DEVELOPMENT APPLICATION ASSESSMENT REPORT

| Application Number: | DA2022/1788 |
| Land to be developed (Address): | Lot 1 DP 201629, 22 Richmond Road SEAFORTH NSW 2092 |
| Proposed Development: | Alterations and additions to a dwelling house including a pergola. |

Figure 1 - Height of Buildings Non-Compliance

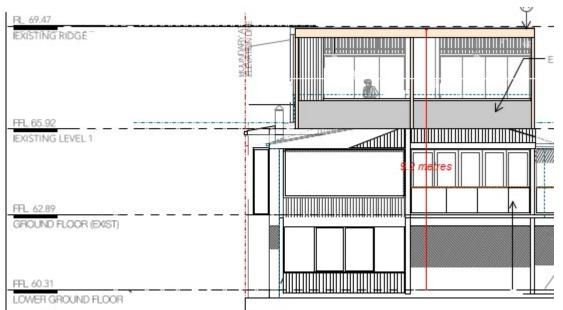
Description of non-compliance:

| Development standard: | Height of buildings |
| Requirement: | 8.5m |
| Proposed: | 9.2m |
| Percentage variation to requirement: | 8.2% |

- The nature of the topography and excavated levels are the primary reasons the proposed pergola breaches the height limit.
- The area of the awning that breaches the height limit is typical of structures on the lower side of Richmond Road.
- The pergola is located entirely above an existing approved balcony and sits slightly below the leading edge of the dwelling facade.
- As the pergola is located on the eastern (rear) side of the dwelling, it will largely remain unseen from the public domain in Richmond Road.

In this regard, the applicant's written request has demonstrated that the proposed development is an orderly and economic use and development of the land, and that the structure is of a good design that will reasonably protect and improve the amenity of the surrounding built environment, therefore satisfying cls 1.3 (c) and (g) of the EPA Act.

Therefore, the applicant's written request has adequately demonstrated that there are sufficient environmental planning grounds to justify contravening the development standard as required by cl 4.6 (3)(b).

Therefore, Council is satisfied that the applicant's written request has adequately addressed the matters required to be demonstrated by cl 4.6(3).
